**R600, R1000  
 System Master**

DRAWN BY: GEORGE DREYER	DATE: 10JUNE97
APPROVED:	DATE:
PCB NO: 30-40600	REV: I
ASSY. NO: 80-40626	REV: L1
NO: 80-41000	REV: L1
REVISED BY: C. MCEUEN	DATE: 5NOV99

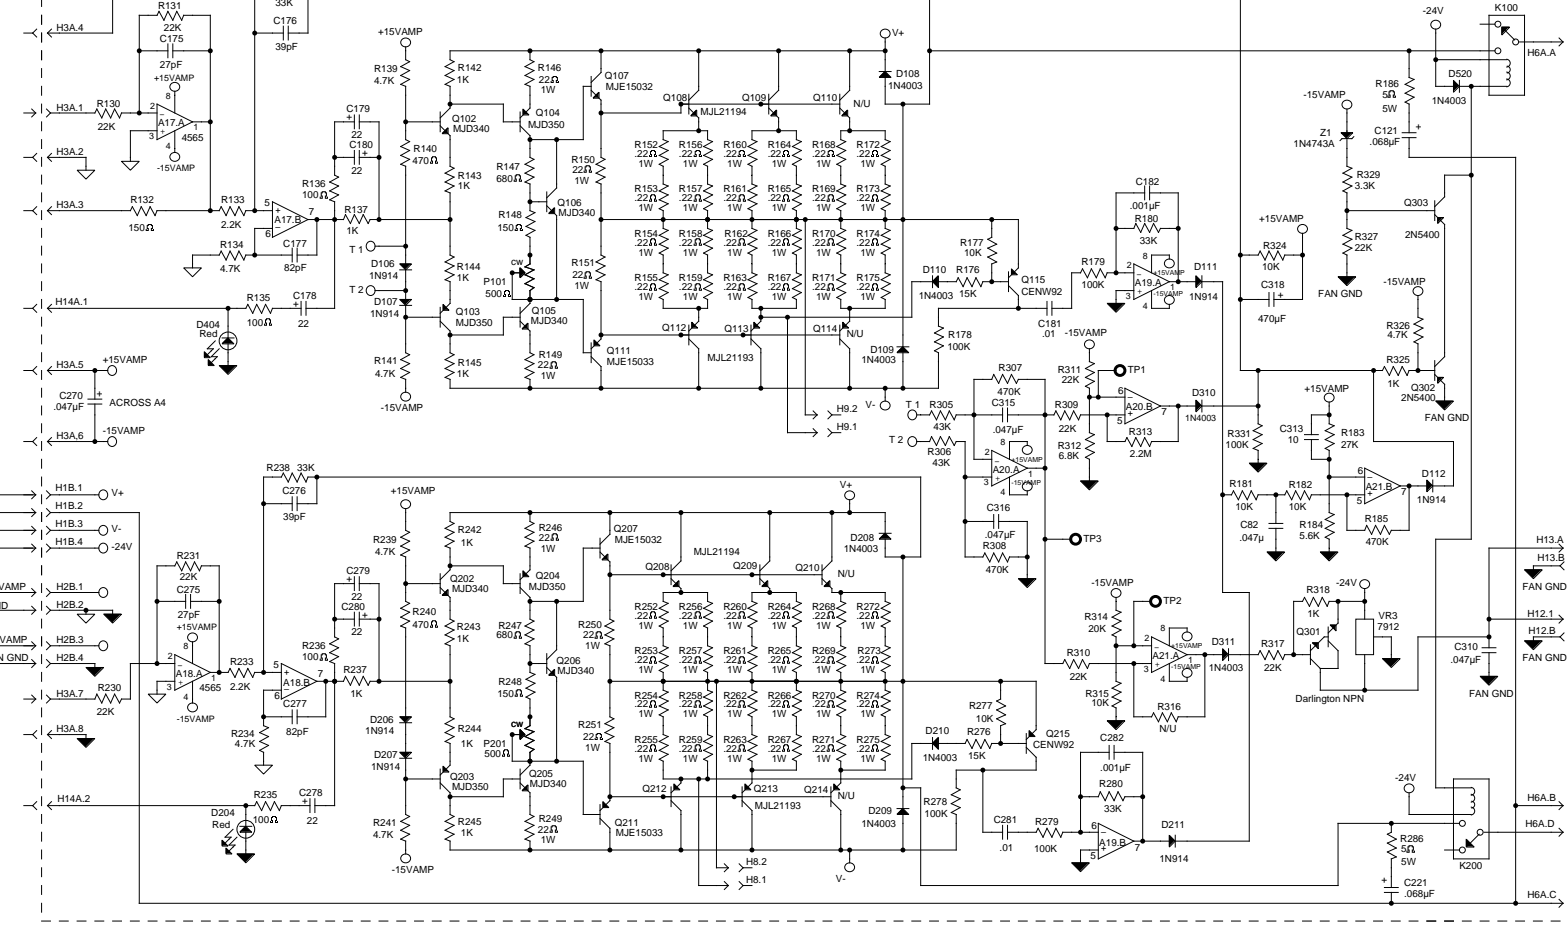
- Changes from Assembly Rev (H3).  
 1. Revised jacks to front panel.  
 2. Revised header numbering.  
 3. Revised PCB to Rev (G).

- Changes from Assembly Rev (H4).  
 1. Moved Clip LEDs to Front PCB: D103, D203.  
 2. Revised headers H3 & H14.  
 3. Revised PCB to Rev (H).

- Changes from Assembly 80-41000 Rev (I).  
 1. R519 from 100Ω to 36Ω.

- Changes from Assembly 80-41000 and 80-40626 Rev (J&I).  
 1. C28 from .022u to .033u.

- CHANGES FOR R1000 ASSEMBLY: 80-41000  
 1. Add Q110, Q210 (Type: MJL 21194).  
 2. Add Q114, Q214 (Type: MJL 21193).  
 3. Add R168-R175, R268-R275 (0.22Ω).  
 4. Change C501, C502 to 10kMf @ 80V.
